Pre-Application Report

Case Number / AMANDA No.	PRE-AP21-139 / 21-123023-PA
Conference Date	January 3, 2022
Applicant	Alex Karcher 875 Country Club Road Eugene, OR 97401 alex@teamjck.com
Agent	Cam Fultz 7209 Greenwood Avenue N Seattle, WA 98103 cam@cba-arch.com
Case Manager	Pamela Cole

Project Description & Property Information	
Project Description	Pre-application conference to discuss development of a building pad within SPR-ADJ-DAP20-26 Phase II-A, including a new building with a drive-through, pedestrian access, parking lot modifications, and landscaping modifications adjacent to Center Street NE. as well as a second building without a drive-through. The development is within Willamette Town Center, a 49.9-acre development site.
Property Address	753 Lancaster Drive NE (Attachment A)
Assessor's Map and Tax Lot Number	Marion County Assessor Map and Tax Lot 072W19CC05403 and 072W19CC05404, within the development site that includes Marion County Assessor Map and Tax Lot numbers: 072W19CC / 04200, 04504, 04600, 04700, 05300, 05400, 5402, 5403, 5404, and 5800
Existing Use	Shopping center
Neighborhood Association	North East Salem Community Association (NESCA)
Adjacent Neighborhood As

**OVERLAY OF CURRENT PROPOSAL ON TO PHASE II-A
DEVELOPMENT PER SPR-ADJ-DAP20-26 DECISION**

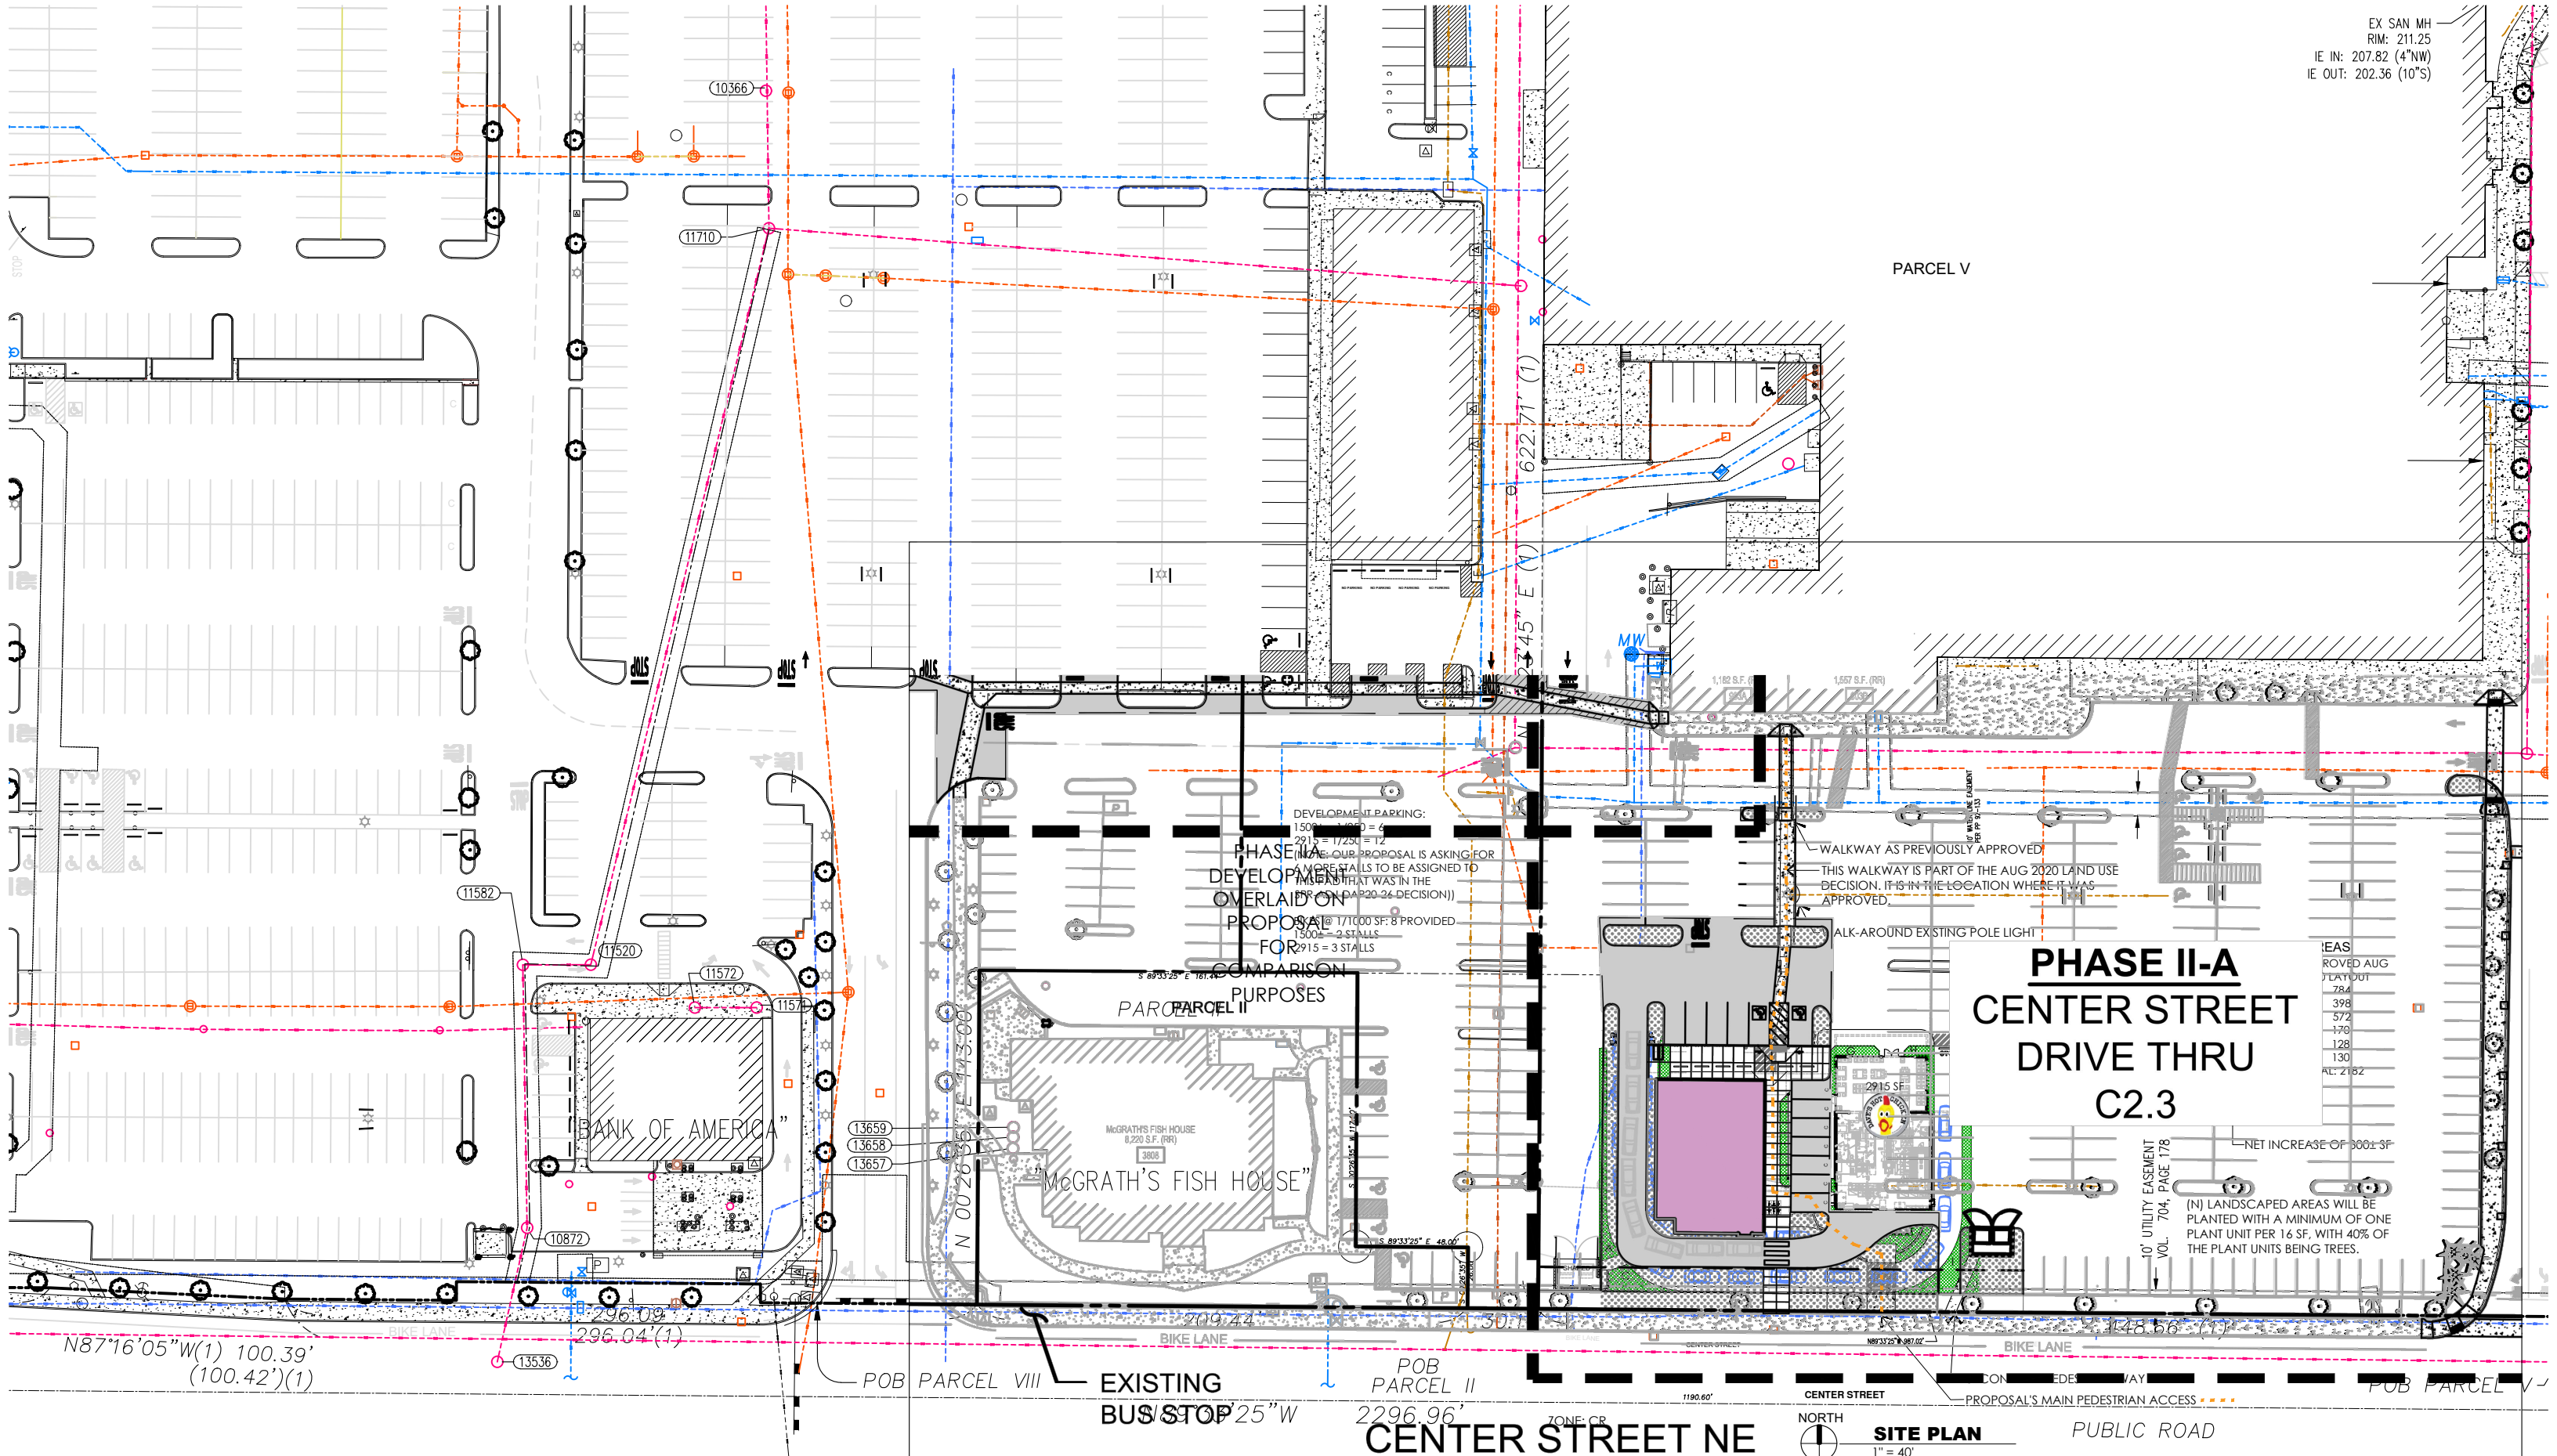
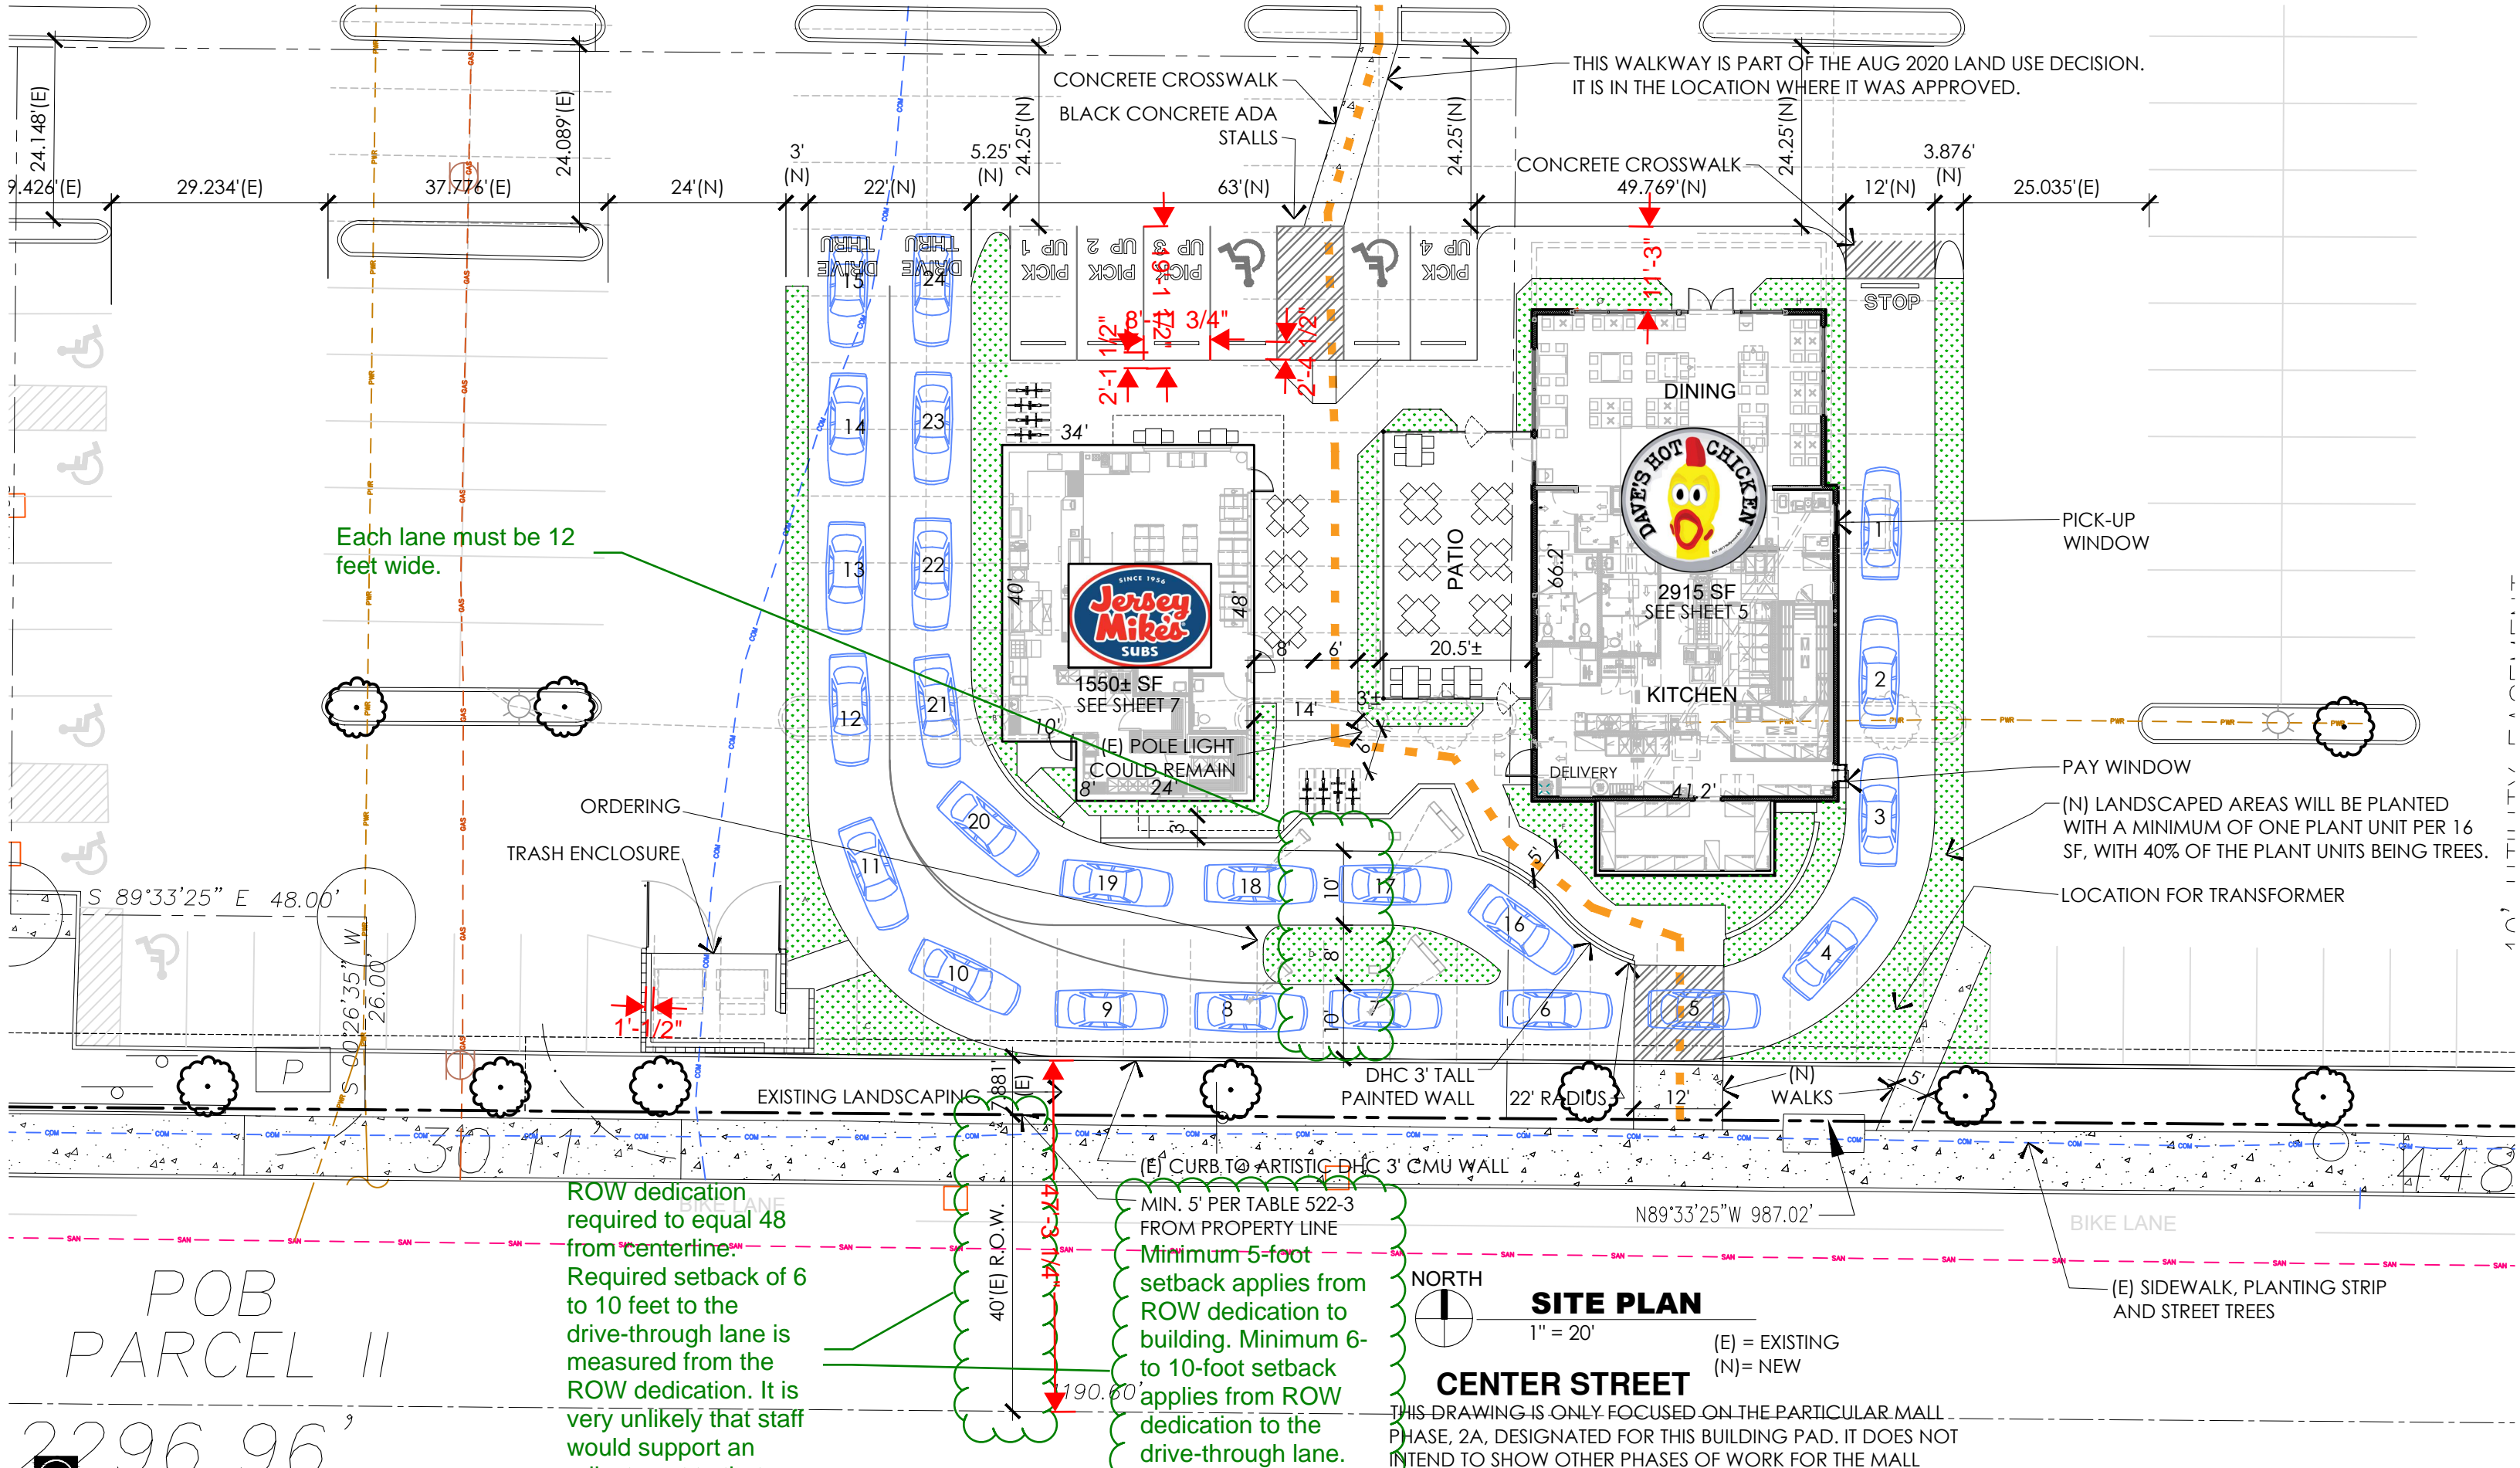
- Condition 1: Provide solid waste service areas meeting all applicable standards of SRC 800.055 for Phase II-A and Phase II-B. **The preliminary site plan relocated the solid waste enclosure from the previously reviewed location that met setback standards to a location that probably does not meet standards. If the solid waste service area has a roof, it is an accessory structure and must be at least 5 feet from the right-of-way dedication that creates a new front property line (Condition 8). If the area is screened with a minimum six-foot-tall sight-obscuring fence or wall, the standards of SRC 800.050 limit the fence or wall to a maximum height of eight feet when located within 10 feet of the right-of-way dedication, but sight-obscuring fences or walls over 30 inches in height are not allowed within 10 feet of the right-of-way dedication. The preliminary plan does not have enough detail to allow staff to confirm that the enclosure meets all of the standards for separation of 1.5 feet between receptacle and side wall, vertical clearance, enclosure standards, four-inch curb 12 inches inside the perimeter of the outside walls, restrainers for gates in open and closed positions, "No Parking" signage, etc.**

- meets the standard. The preliminary site plan does not show this required pedestrian connection at the eastern edge of the parking lot that serves the proposed buildings and Joann's.

- Condition 6: For Phase II-A, provide at least four bicycle parking spaces that meet the development standards of SRC 806.060. The requirement would be four spaces for each new building. The spaces north of Jersey Mike's do not meet location standards (within 50 feet of / visible from primary entrance) or bike rack standards. The spaces east of Jersey Mike's do not meet bike rack standards. No bike spaces are depicted within 50 feet of primary entrance for Dave's.

- Condition 8: For Phase II-A, convey land for dedication on Center Street NE to equal a halfwidth right-of-way of 48 feet along the development frontage of Phase II-A, approximately 177 feet. The proposed site plan does not indicate this right-of-way dedication. The 6- to 10-foot setback to the drive-through lane would be measured from the newly dedicated right-of-way. The proposed site plan does not indicate a setback from the new right-of-way. It is very unlikely that Planning would support an adjustment to the setback standard because a property-line sidewalk is preferred.

the Center Street NE public sidewalk on the west edge of the interior driveway, crossing the interior driveway from west to east, and connecting to the existing private sidewalk on the west side of the US Bank building, as shown on the proposed site plan. **The preliminary site plan does not show these pedestrian connections.**

Parking stalls north of the building do not meet standards for 9 x 19 standard or ADA spaces. The stripes are 18 feet in length and the wheelstops are not in the correct location. If separate wheelstops are provided, the face nearest the vehicle must be 17 feet from the back end of the parking space to allow a two-foot overhang.

Where the drive-through lane splits in two, each lane is required to be 12 feet wide. The Development Review Team was concerned that larger vehicles such as pickup trucks would have difficulty maneuvering in the narrower lanes and does not support an adjustment to reduce the width to 10 feet for each separated lane.
